From: Bedolla, Hector H@DOT <hector.bedolla@dot.ca.gov>
Sent: Friday, September 27, 2024 10:13 AM
To: Solorzano, Lourdes
Cc: Phan, Bao T@DOT; Yamashiro, Fawne K@DOT; Medina, James@DOT; Melgoza, Ana; Jreij, Wahib G@DOT; Ng, Mandy@DOT; Duong, Trung S@DOT; De Leon, Dean@DOT
Subject: RE: 07-36100 - Ven-118 - Pavement Rehab Project - Bike Lanes in Saticoy - Outreach to Saticoy Municipal Advisory Council

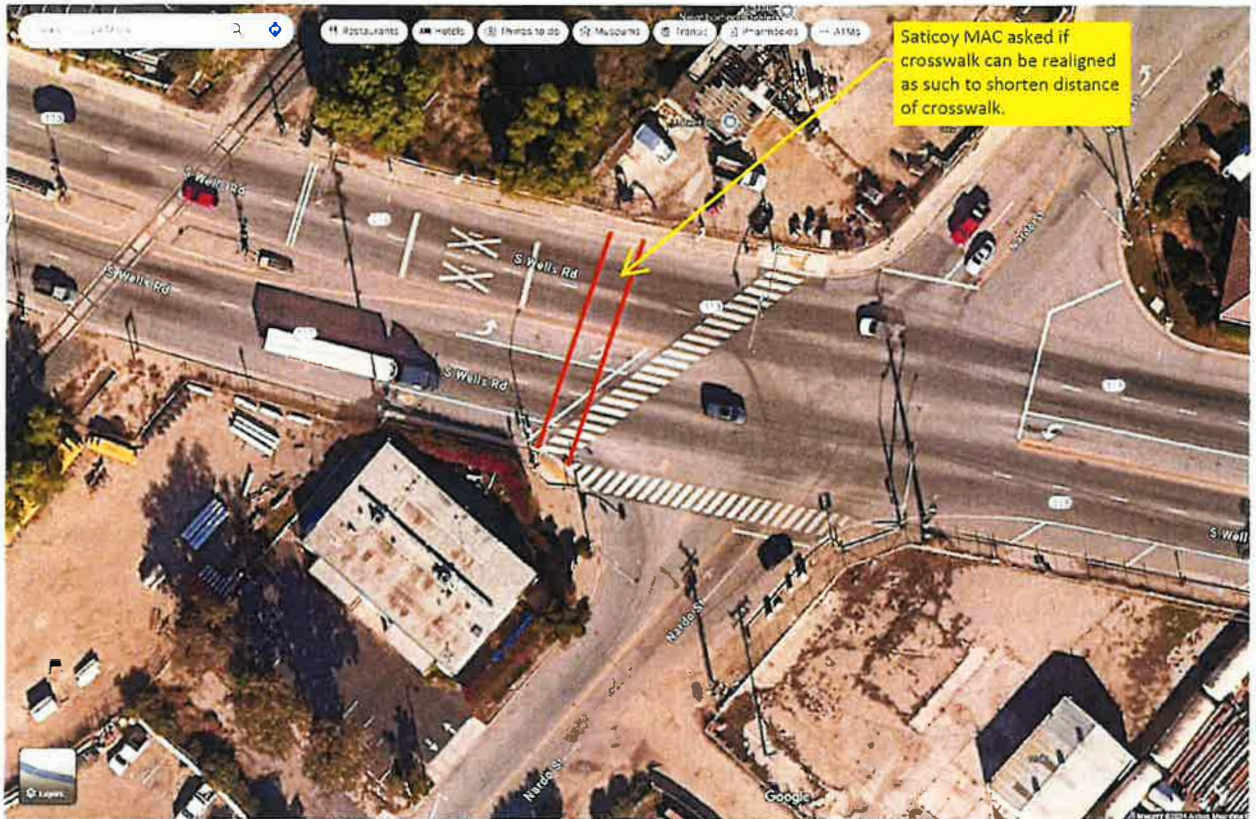
- During conversation of the above item, it was asked if the skewed crosswalk may be realigned to be perpendicular to the roadway and thus shortening the distance needed to cross Wells Road. See sketch below:

I checked with our Traffic Safety and Corridor Management units on this proposal and they recommended against it. The realigned crosswalk may be costly and may introduce safety concerns including the following:

- A shortened eastbound (EB) left turn lane thus reducing its storage capacity.
- NB and SB Nardo Street traffic may experience reduced visibility of pedestrians on the crosswalk. Since the crosswalk is offset from the NW corner, it will be increasingly difficult for SB Nardo Street traffic turning right to see pedestrians waiting to cross south.

- A new signal poles for the pedestrian signal and pedestrian push button would be required at the NW corner.
- A new curb ramp at the NW corner would be needed.
